COLLEGE ROAD AFFORDABLE HOUSING

STAFF REPORT

RE: **5220, 5224, 5228, & 5230 College Road
(permit application # T2019-0192)**

FROM: Karen DeMaria, City of Key West Urban Forestry Manager

SHEET NUMBER: L-1
JOB #: 19003 DRAWN BY: LBR
THIS DRAWING IS THE PROPERTY OF LANDWISE DESIGN, INC. UNLESS OTHERWISE PROVIDED FOR BY CONTRACT, THE CONTENTS OF THIS DRAWING ARE CONFIDENTIAL AND SHALL NOT BE TRANSMITTED TO ANY OTHER PARTY EXCEPT AS AGREED TO BY LANDWISE DESIGN, INC.
© Copyright 2018

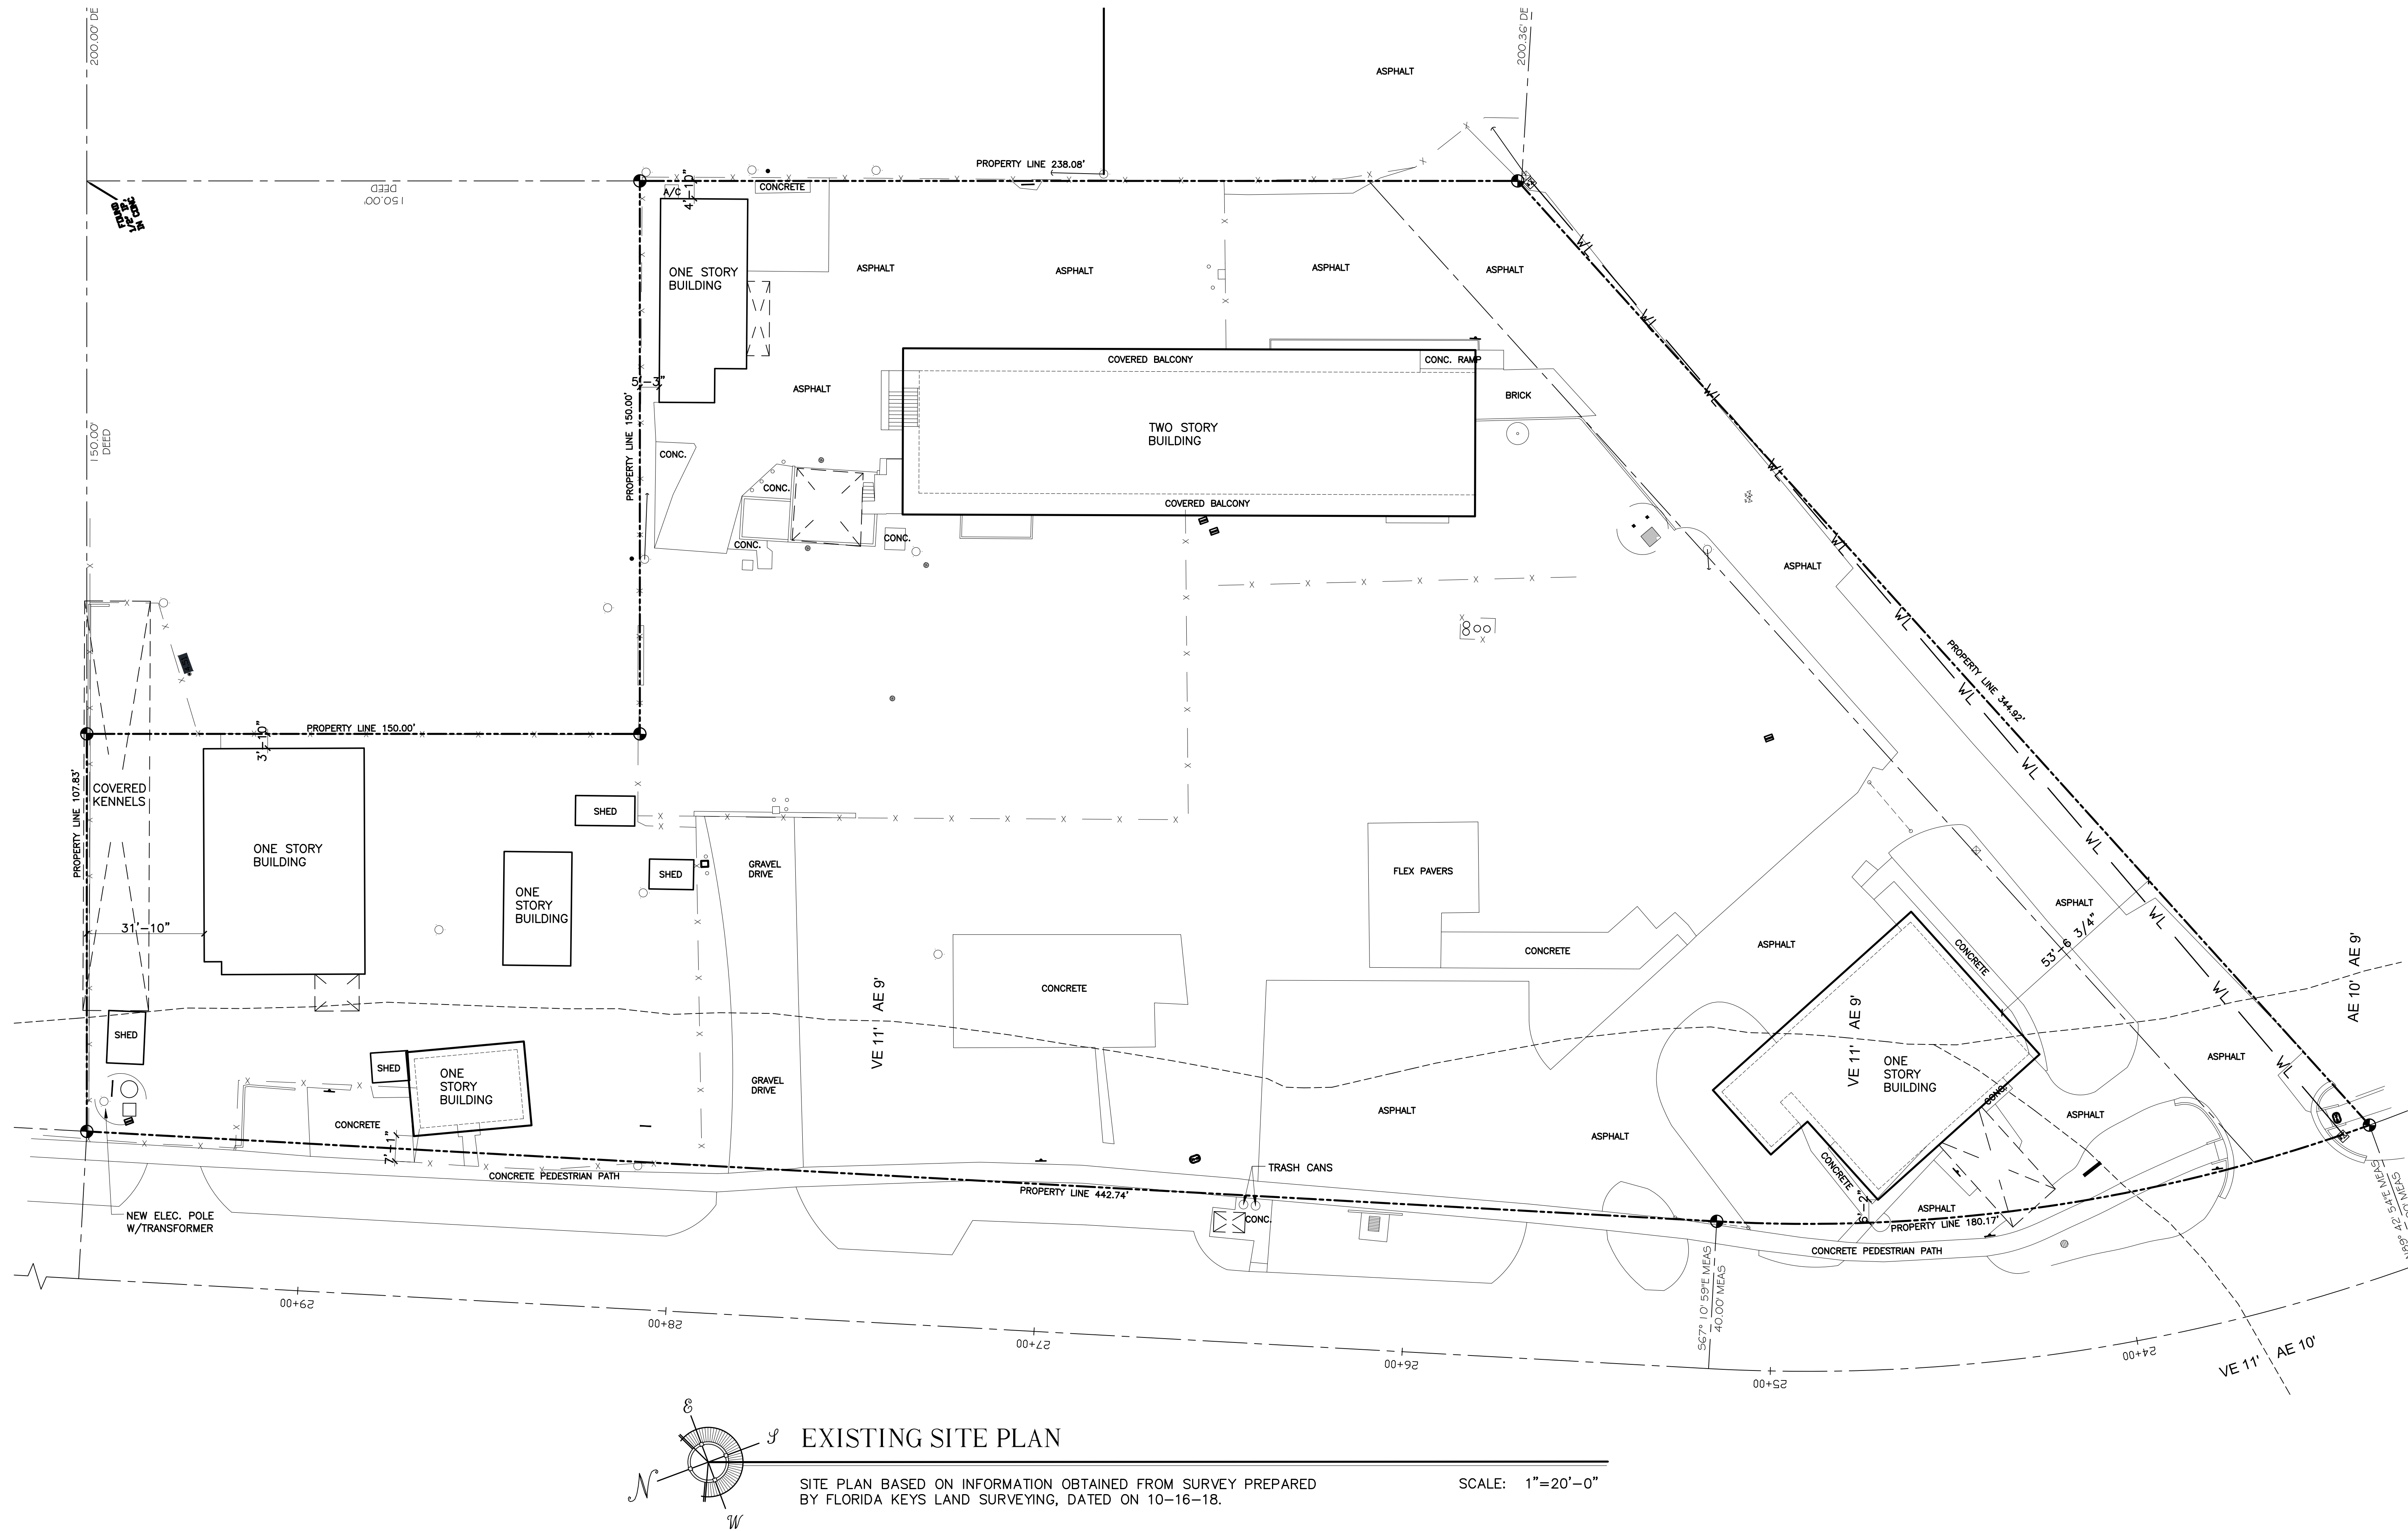
Recommendation: Recommend approval of the Conceptual Landscape Plan With Tree Removal at 5220, 5224, 5228, & 5230 College Road to include the approval of the removal of (1) Mahogany tree (Tree #6) with the additional replacement of 24.2 caliper inches of approved trees for a total of 225.8 caliper inches of

**native dicot and/or fruit trees from the approved list, FL#1, and 5-
native palms, 4 ft tall each palm to be planted onsite with the
transplanting of (4) Thatch Palms, all to be incorporated into the
landscape plan.**

At the April 9, 2019 Tree Commission meeting, approval was given to remove and transplant other trees on the property. At that time, this tree was slated to remain and be preserved during the development. During final architectural and construction meetings with other departments and FCAA, it was determined that this mahogany tree needed to be removed (Tree #6). The FCAA will be digging a large trench for a new pipeline to the storage tanks to remain behind this complex which will impact the root system of the tree and other requirements with the building location will severely impact the canopy and future growth of the tree (constrict).

Ladd, we have decided to remove the #6 tree, mahogany, near building C. It is the one that is too close to the building. Can you please revise your plan as such? Also please add required calipers required for removal, preferably mahogany. Thanks sorry for late notice but we need to get it settled today if possible.

I have removed Tree #6/Mahogany and used a mitigation calculation of 83% which equals 24.3" of replacement to mitigate. Karen, I used 75%/100%/75% values for Location/Species/Condition, I hope this is acceptable.....Let me know.

GENERAL INFORMATION & TREE MITIGATION		
ZONING / LAND USE	HDR-1	
GROSS SITE AREA	116,024.48 or 2.66ac	
BUILDING COVERAGE	SEE ARCHITECTURAL	
IMPERVIOUS SURFACE AREA	SEE ARCH./CIVIL	
TREE MITIGATION CALCULATIONS	DSH INCHES REQUIRED	
TREES IMPACTED		
25 REGULATED TREES REMOVED		
REPLACEMENT INCHES REQUIRED	225.8"	(added 24.25" for #6 Mahogany)
REPLACEMENT INCHES PROVIDED	226" +

1. 4.23.19 Rmvd #6 Mahogany/83% Mit. Added
